H. B. ROBINSON UNIT NO. 2  
LICENSE DPR-23  
SAFETY INJECTION PUMP PERFORMANCE

In response to your request of November 28, 1973, Carolina Power & Light Company submits Operating Plant Change No. 1 to the H. B. Robinson FSAR. Incorporated in this proposed change to the FSAR are minimum performance characteristics for the safety injection pumps and the supporting safety analyses for the small break loss-of-coolant accident (LOCA).

FINAL SAFETY ANALYSIS REPORT  
OPERATING PLANT CHANGE NO. 1

Figure 6.2-7

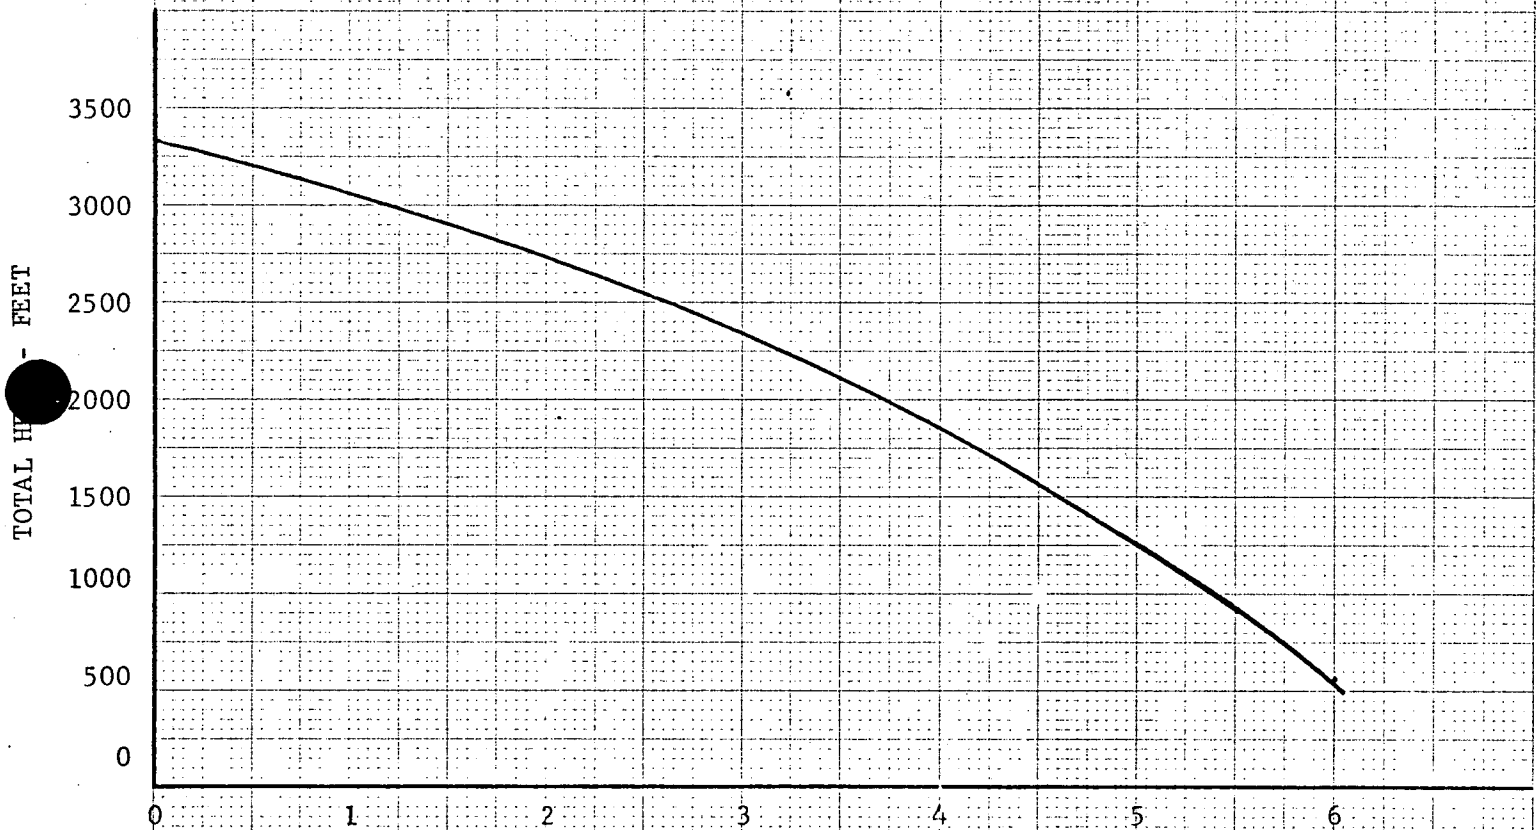
The three high-head safety injection pumps for supplying borated water to the Reactor Coolant System are horizontal centrifugal pumps driven by electrical motors. Parts of the pump in contact with borated water are stainless steel or equivalent corrosion resistant material. A minimum flow bypass line is provided on each pump discharge to recirculate flow to the refueling water storage tank in the event the pumps are started with the normal flow paths blocked. The design parameters are presented in Table 6.2-7 and Figure 6.2-7 gives the performance characteristics of these pumps.

The performance characteristic in Figure 6.2-7 reflects the measured performance of the pumps as determined during the Cycle 1 - Cycle 2 refueling outage. The measured pump performance in combination with the measured system resistance results in a system delivery rate that is conservative with respect to those used in the steam break and the small break LOCA safety analyses, which are shown in Figure 14.3.2-17.

The revised minimum performance curve corresponds to the measured pump characteristics determined during the refueling outage and reported in our letters of May 25, 1973, and September 7, 1973. This performance, in combination with the measured Safety Injection System resistance, results in an integrated flow delivery that is conservative with respect to that used in the safety analyses reported to you in our letters of January 25, 1971, and December 8, 1971.

Figure 14.3.2-17

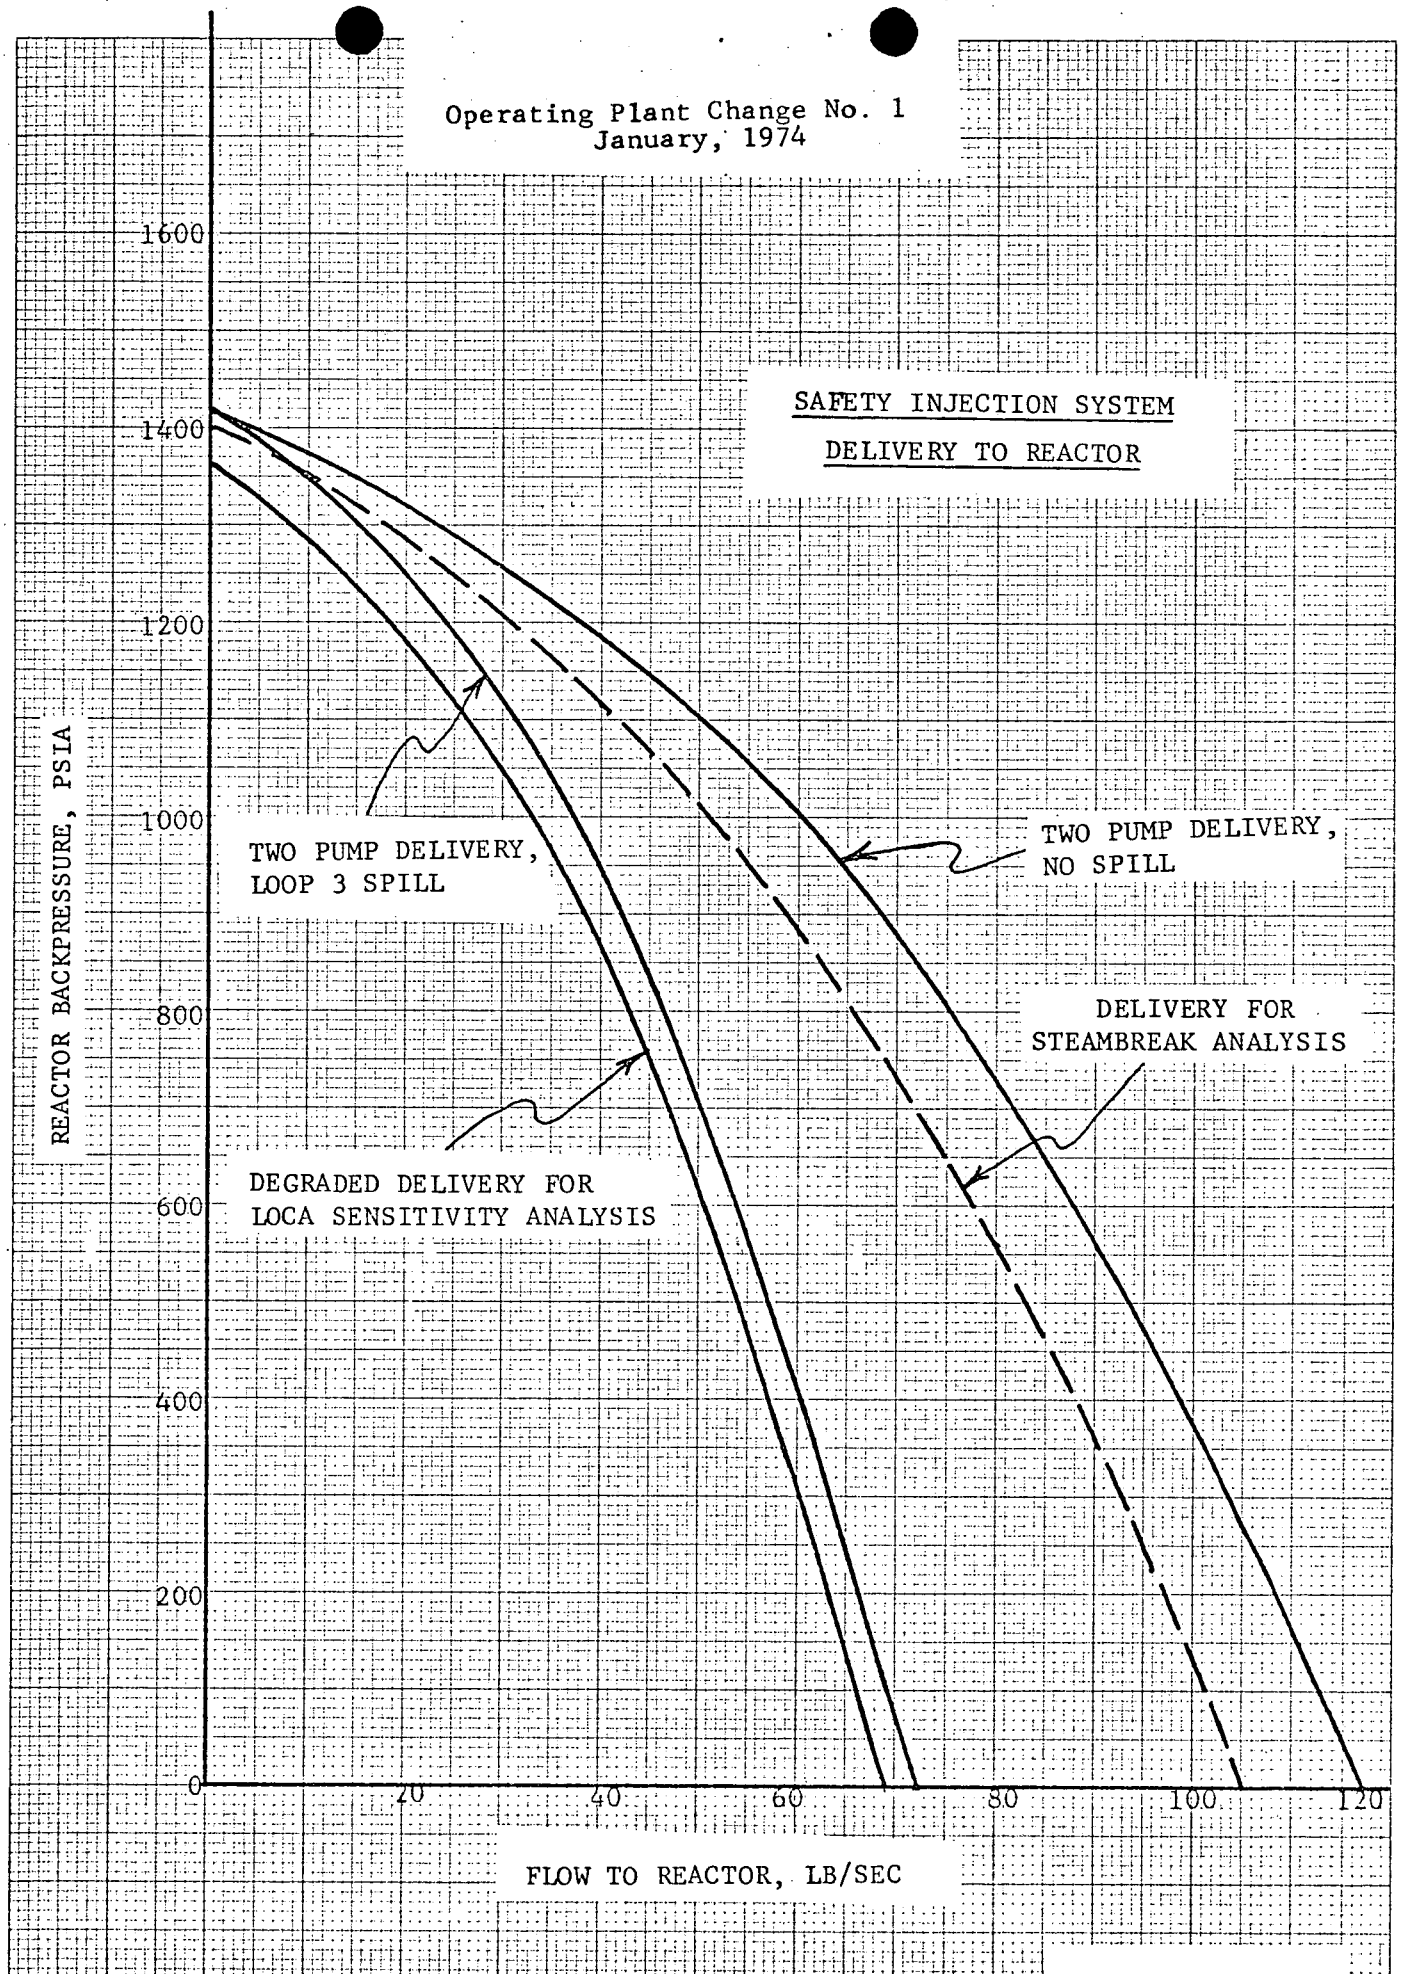
1.30 would be experienced. In the analysis presented in WCAP-8243, for 2300 MWt operation, the same delivery rate was assumed. The delivery curve used in previous analyses of the steam break accident and the curve referred to above are incorporated in revised Figure 14.3.2-17 in the attachment and will be referenced in the uprating amendment.

The analyses are based on hot leg injection being blocked,<sup>(19,20)</sup> with a single failure of one emergency diesel generator or power train resulting in two safety injection pumps delivering separately through three cold leg lines. The lowest resistance cold leg line is assumed to spill its flow to the containment through the break. The delivery curve for this case is presented in Figure 14.3.2-17. The pump discharge pressures indicated include the 5% reduction used in these analyses.

Safety injection pump and system performance was again measured and reported in May, 1973<sup>(23)</sup>. The measured performance was the same as used in the small break analysis for reactor backpressure less than 900 PSIG. At higher backpressures, the measured performance was somewhat better than that used in the analysis. In order to access the effect of possible pump wear, the system performance was arbitrarily degraded by reducing both extremes on the pump performance curve (1) shutoff pressure and 2) runout flow by 5% each and constructing a curve of similar shape (to the original curve) through those points. The resulting curve (Figure 14.3.2-17) shows a reduction of approximately 10% in "Flow to Reactor" at 1000 PSIG backpressure.

CPL Small Break LOCA Analyses Pressure History  
Min. Safety Injection

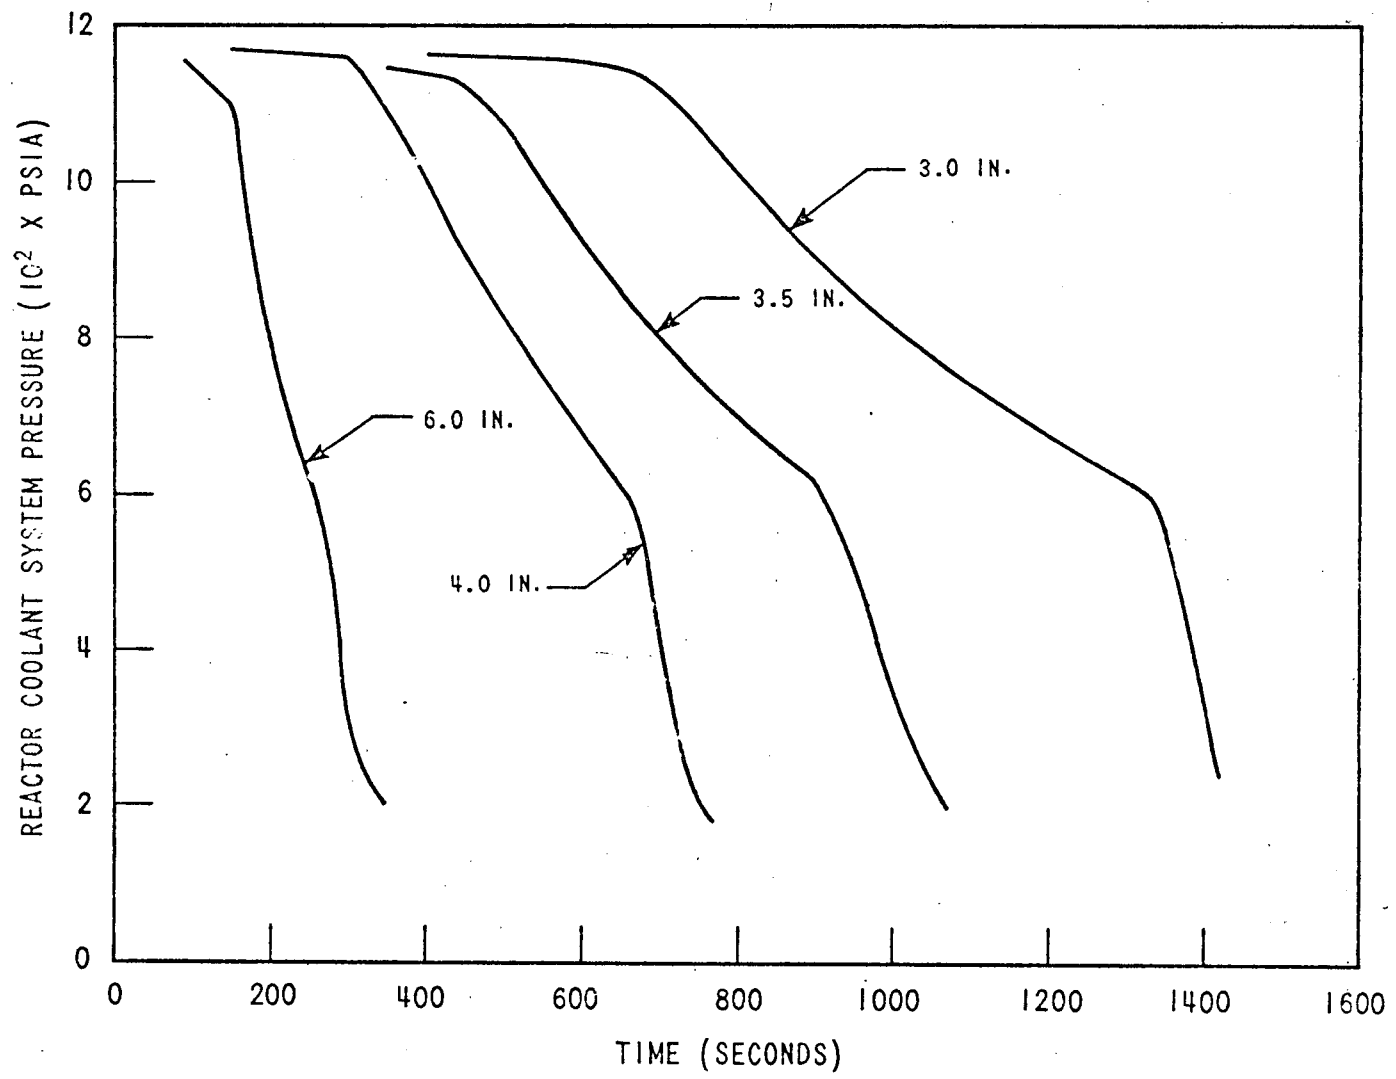
The Reactor Coolant System pressure and volume for the range of break sizes are presented in Figure 14.3.2-18 and Figures 14.3.2-22 through 14.3.2-25, respectively. The volume figures illustrate both quiet and froth levels.
